LANDSCAPE CSW WALLMAN ARCHITECTS

23.08.2012 FORMAL SUBMISSION

Design Response to UDRP Pre-consult Recommendations

485 RICHMOND ROAD, OTTAWA

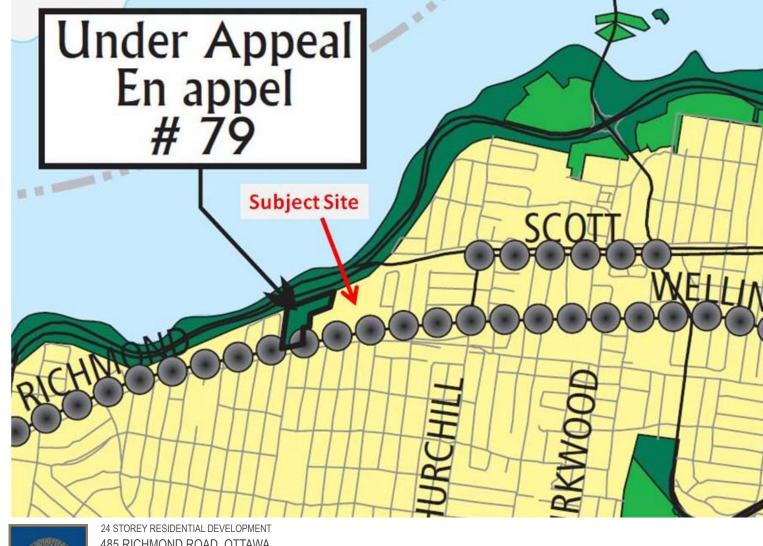
- consideration of above ground car parking and how it is screened has been addressed through the use of vertical panels on the north and south elevations, while directing the facade openings away from public view. east and west elevations are to remain solid.

- the integration of residential suites on the north (ottawa river) elevation provides active habitable space adjacent to the parkway. this residential area replaces what formerly was communal area which now is situated on the podium deck.

- residential townhomes have a direct relationship to the parkway with level 5 resdential suites over look the parkway. these features will improve the area along the parkway and create a much greater sense of safety for commuters, pedestrians and cyclists.

- entry pathways and driveways now provide an intuitive pedestrian route to the buildings entry vestibule while seperating both pedestrian and vehicular movement.

- the overall entry to the proposed building improves with the relocation of the podium parking ramps to the west of the entry lobby. this creates a greater focal point from richmon road.

- we continue to work with city of ottawa staff to explore a safe and efficient route for pedestrians. this route could possibly be located along maplelawn gardens on the wester portion of te site. as such, routes shown on the architectural drawings may change.
